Access Compliance Report Public Rights-of-Way (Curb Ramps)

Main Street: BOLSA_AVE_FRONTAGE_ROAD Cross Street: N/A Location: S

ADA ID: RPAT220221152401 Ramp Type: Type 4 - Parallel Initial Pass/Fail: Fail Overall Compliance: No Severity Score: 2

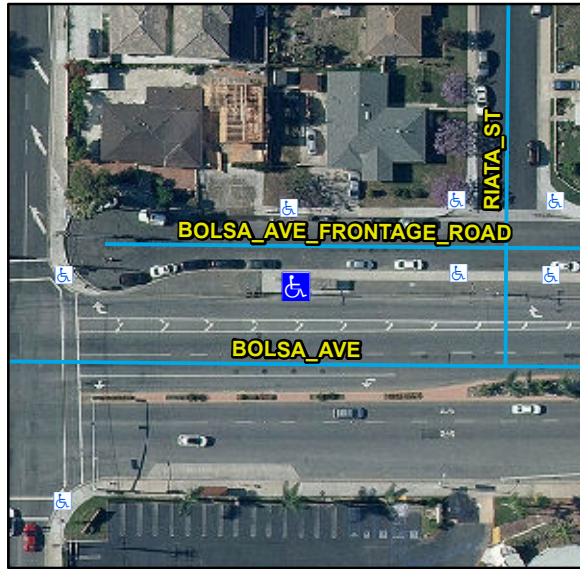
Compliance	Description	Data	Compliance	Description	Data
N/A	Ramp Length LT (in)	96	N/A	Ramp Length RT (in)	105
Yes	Ramp Width LT (in)	53	Yes	Ramp Width RT (in)	53
Yes	Ramp Run Slope LT (%)	7.7	Yes	Ramp Run Slope RT (%)	7.4
Yes	Ramp Cross Slope LT (%)	1.7	No	Ramp Cross Slope RT (%)	2.2
N/A	Landing Present	N/A	N/A	DWS Provided	N/A
N/A	Landing Length (in)	N/A	N/A	DWS Contrast	N/A
N/A	Landing Width (in)	N/A	N/A	DWS Length (in)	N/A
N/A	Landing Run Slope (%)	N/A	N/A	DWS Full Width	N/A
N/A	Landing Cross Slope (%)	N/A		DWS Offset Type	N/A
N/A	Landing Movement Obstructed?	N/A	N/A	DWS Offset Left (in)	N/A
	Landing Movement Type	N/A	N/A	DWS Offset Right (in)	N/A
N/A	Landing Shared	N/A			
N/A	Clear Space	N/A			
N/A	Clear Space To Crosswalk (in)	N/A			
N/A	Marked Crosswalk 1	No	N/A	Marked Crosswalk 2	N/A
	Crossing 1 Direction	N		Crossing 2 Direction	N/A
	Marked Crosswalk 1 Width (in)	N/A		Marked Crosswalk 2 Width (in)	N/A

Remove & Replace Entire Ramp.

R304.5.3, STD 1115
